ADDENDUM NO. 2

February 1, 2019

PROJECT: City Hall Park Improvement Project

E503

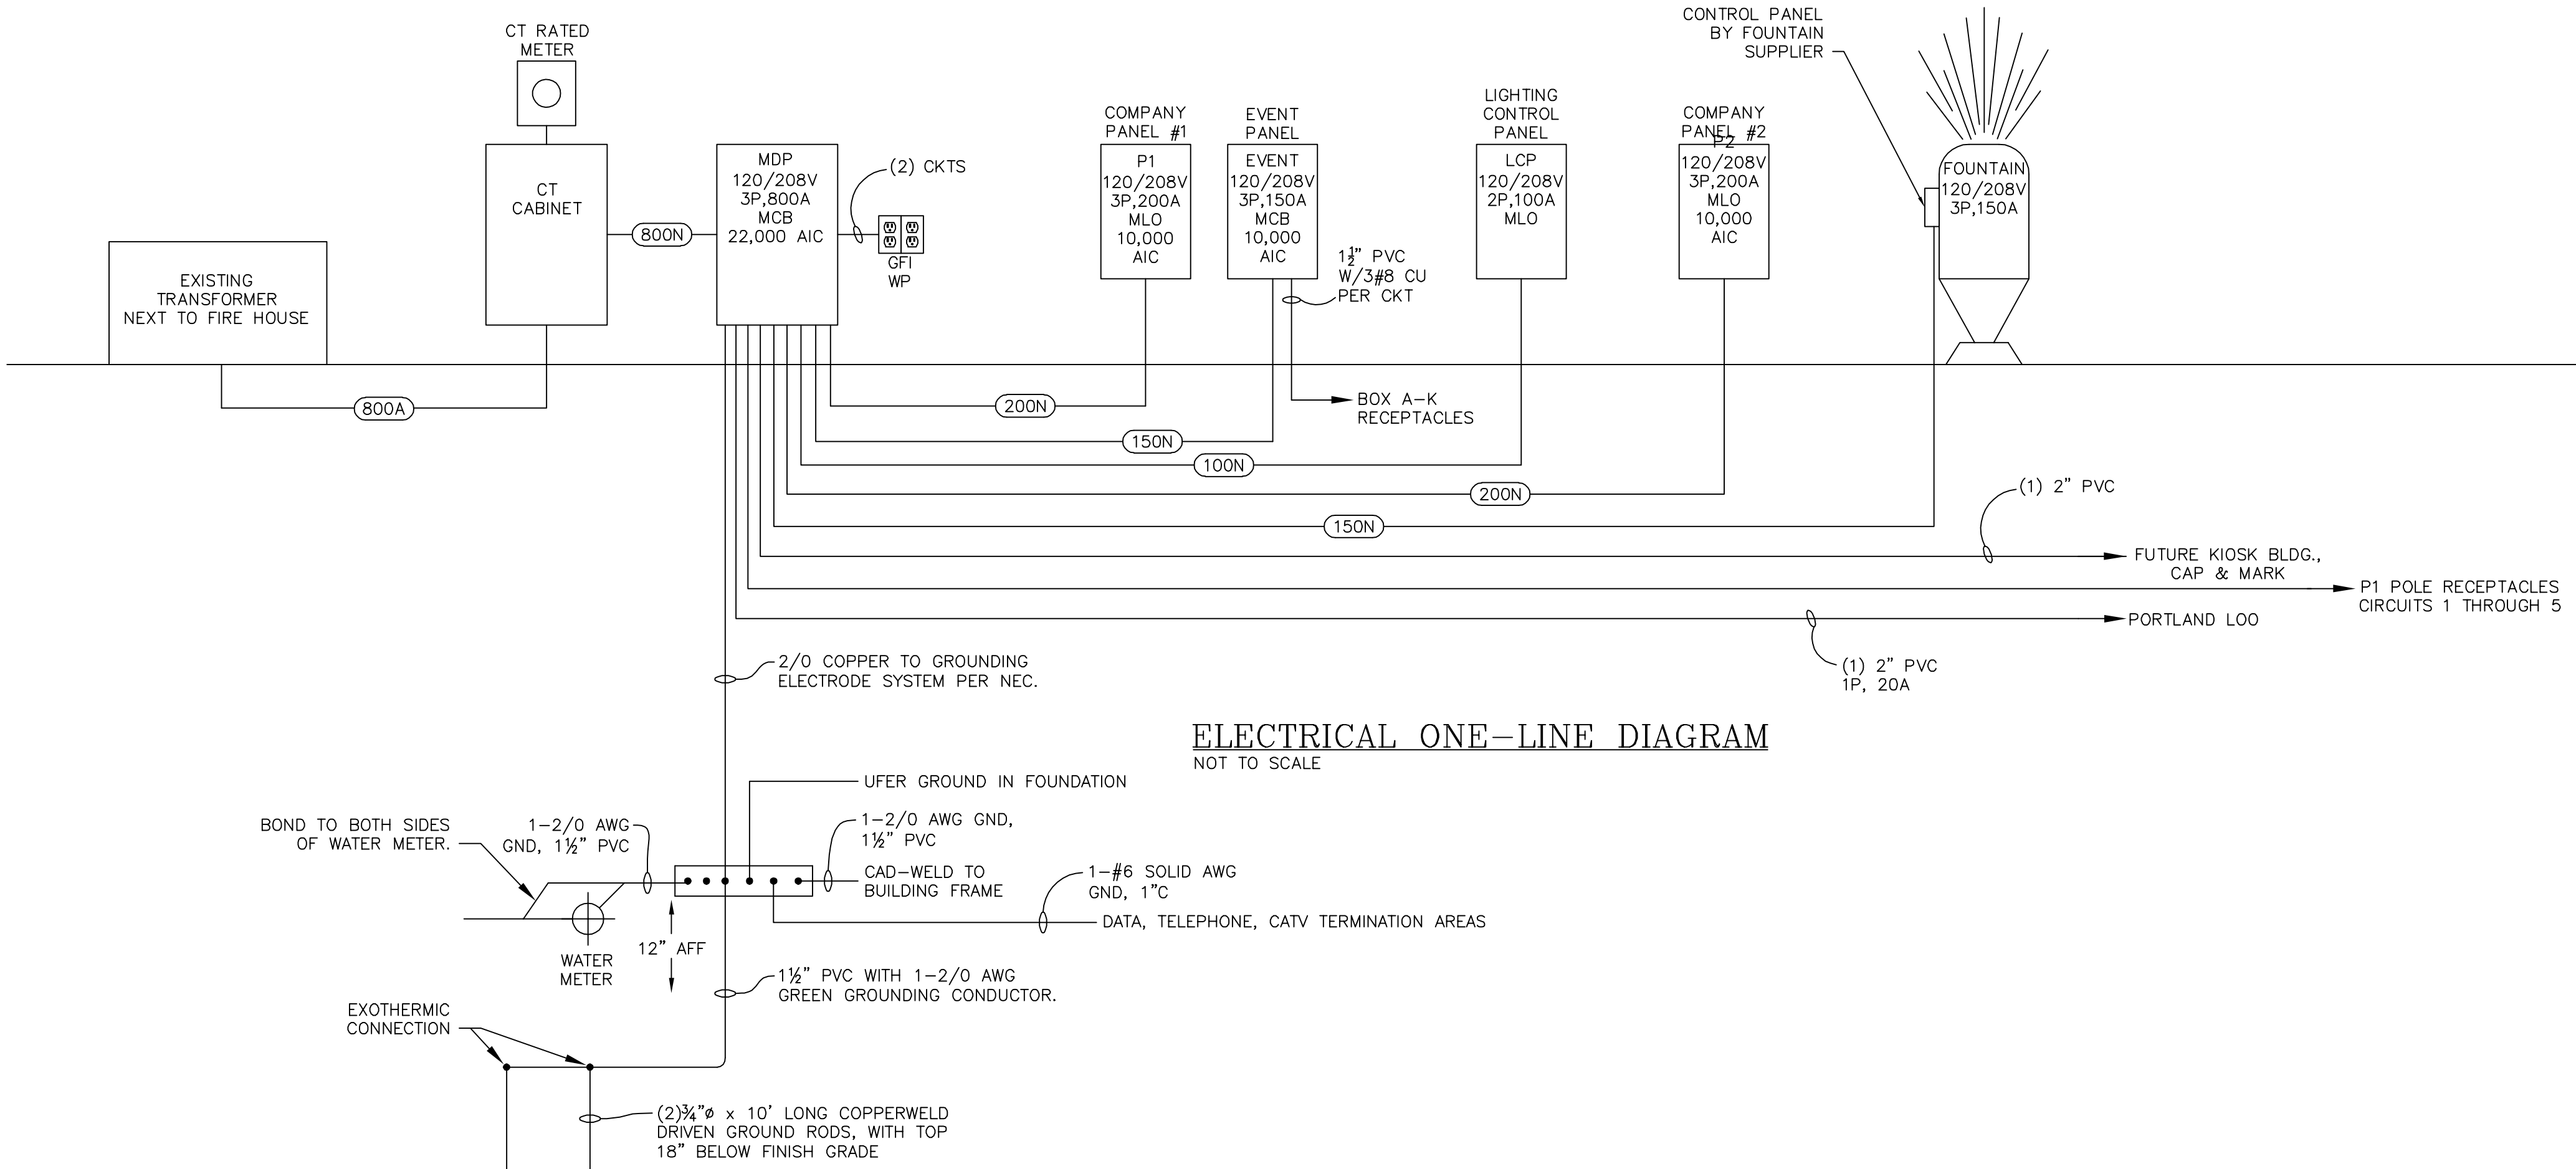
- 1. Sheet C201
 - a. Updated raingarden/bioretenction name labels
- 2. Sheet C509
 - a. Updated Backflow Prevention Vault Details
- 3. Sheet E503
 - a. Updated distribution panel schedules and One-Line Drawing

7. Per Drawing E503 Panel MDP there are no AIC ratings listed- (Company Panel 1, Event Panel LCP, and Company Panel 2).

8. Event Panel per the spec says it's a main circuit breaker, but the E503 one line shows it as an MLO- So question is which option MCB or MLO?

RESPONSE: See revised Sheet E503 for the updated Panel Schedules and One-Line Drawing.

RESPONSE: This is a MCB. See the revised Sheet E503 for the updated Panel Schedules and One-Line Drawing.
